nAUI Ad Hoc

De-emphasis Proposal

Figure 83A–3—Driver output voltage limits and definitions

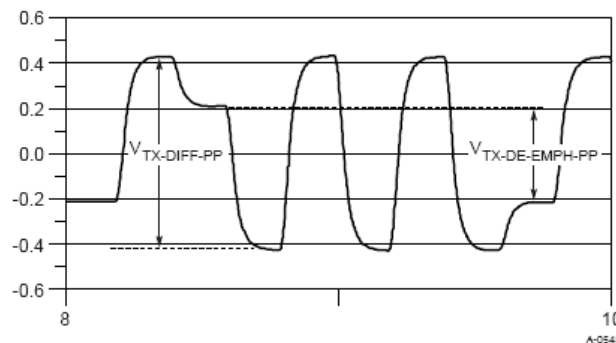
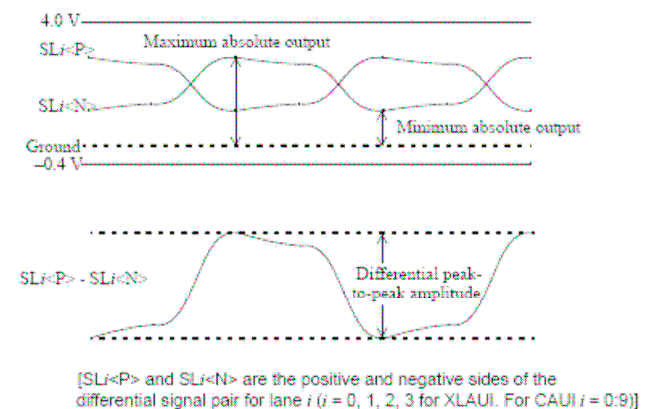
- Add row to Transmitter Characteristics Table 83A-1

Parameter	Value	Units
Minimum De-emphasis	3.5	dB

- Driver differential output amplitude shall be less than 760 mVp-p **and greater than 380mVppd** including transmit equalization. DC referenced logic levels are not defined since the receiver is AC-coupled. Single-ended output voltage range shall be between -0.4 V and 4.0 V with respect to ground.
- **De-emphasis shall be the ratio between the amplitude following a transition and the amplitude during a non-transition bit as seen in equation EEE. Amplitude measurements are taken using an averaged waveform and taken at the center of the respective UI.**
- See Figure 83A–3 for an illustration of absolute driver output voltage limits, definition of differential peak-to-peak amplitude, and definition of pre-emphasis.

$$V_{TX-DE-RATIO} = -20 \log_{10} (V_{TX-DIFF-PP} / V_{TX-DE-EMPH-PP})$$

Rise / Fall Time

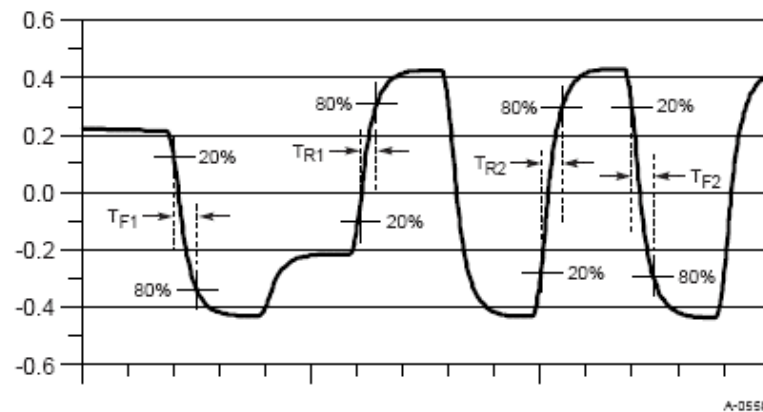
- Rise and fall times are measured from the 20% to the 80% levels of the differential voltage level. Note that, with de-emphasis, the voltage thresholds corresponding to 20% and 80% vary depending on the voltage level of the previous UI. Only those transitions crossing the zero threshold need to meet TR/TF limits defined in Table 83A-1. In Figure YYY, there are three distinct thresholds corresponding to deemphasized transitions from high to low, low to high, and full swing transitions in either direction. Rise / Fall Time must be validated for all four possible cases.

83A.3.3.5 Transmitter eye mask definition

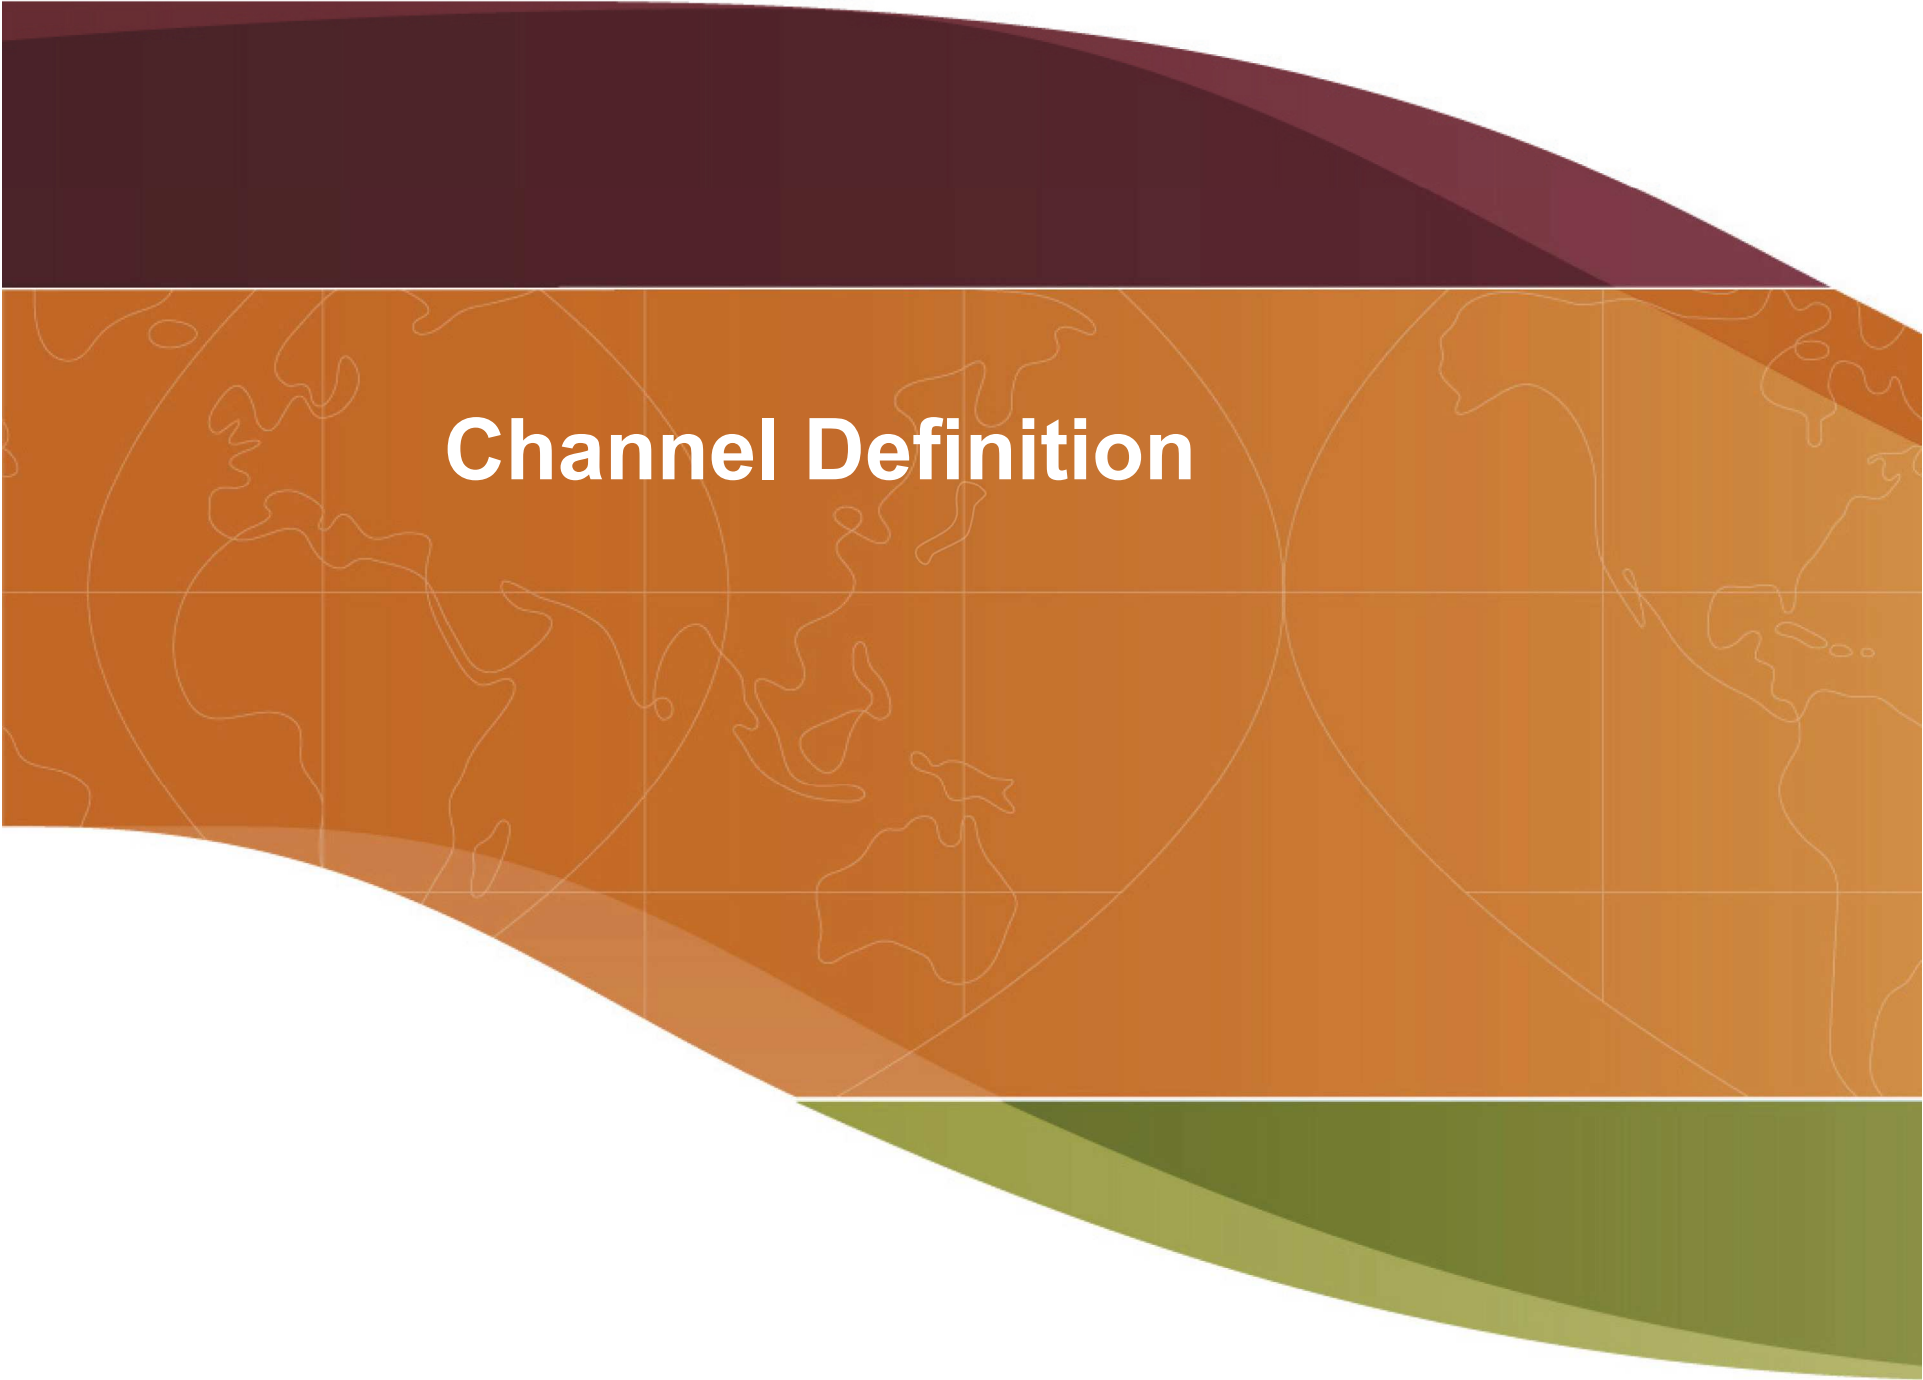
- The eye templates are given in Figure 83A–6 and Table 83A–1. The template measurement requirements are specified in 83A.5.1. The jitter requirements at the transmitter are for a maximum total jitter of 0.32 UI peak-to-peak and a maximum deterministic component of 0.17 UI peak-to-peak. The maximum random jitter is equal to the maximum total jitter minus the actual deterministic jitter. Jitter measurement requirements are described in 83A.5.2, and **are conducted with de-emphasis off.**

Figure xx – Insertion loss limit

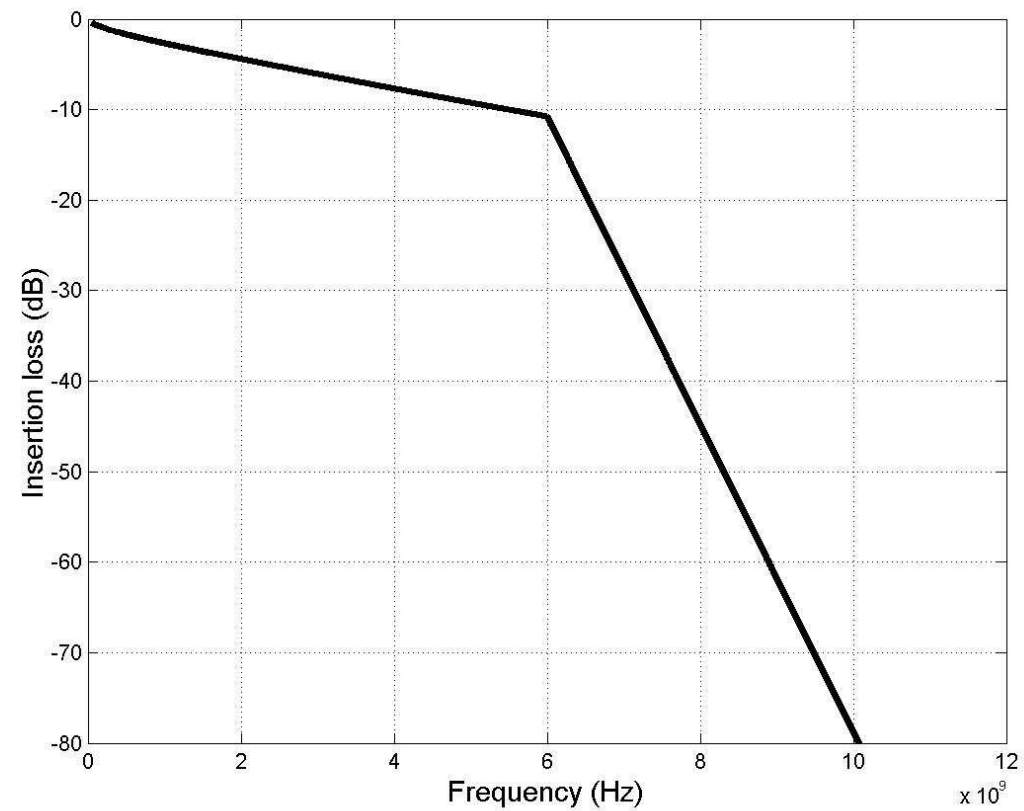
Insertion Loss Definition (83A.4 Table YYY)

Parameter	40/100G XLAUI/CAUI	Units
b_1	-6.52e-006	
b_2	-9.55e-011	
b_3	-8.17e-021	
b_4	6.06e-031	
f_1	0.05	GHz
f_2	6	GHz
f_{max}	11.1	GHz

$$S21(f) \leq S21_{\max}(f) = 20 \log_{10}(e) \times (b_1 \sqrt{f} + b_2 f + b_3 f^2 + b_4 f^3)$$

$$S21(f) \leq S21_{\max}(f) = S21(f_2) - 1.7 \times 10^{-8} (f - f_2)$$

- This section describes informative characteristics which are used to describe an XLAUI / CAUI channel.
- The informative values for insertion loss are summarized in table YYY and equation ZZZ. Other impairments such as crosstalk can have a material impact on the link performance and should be minimized
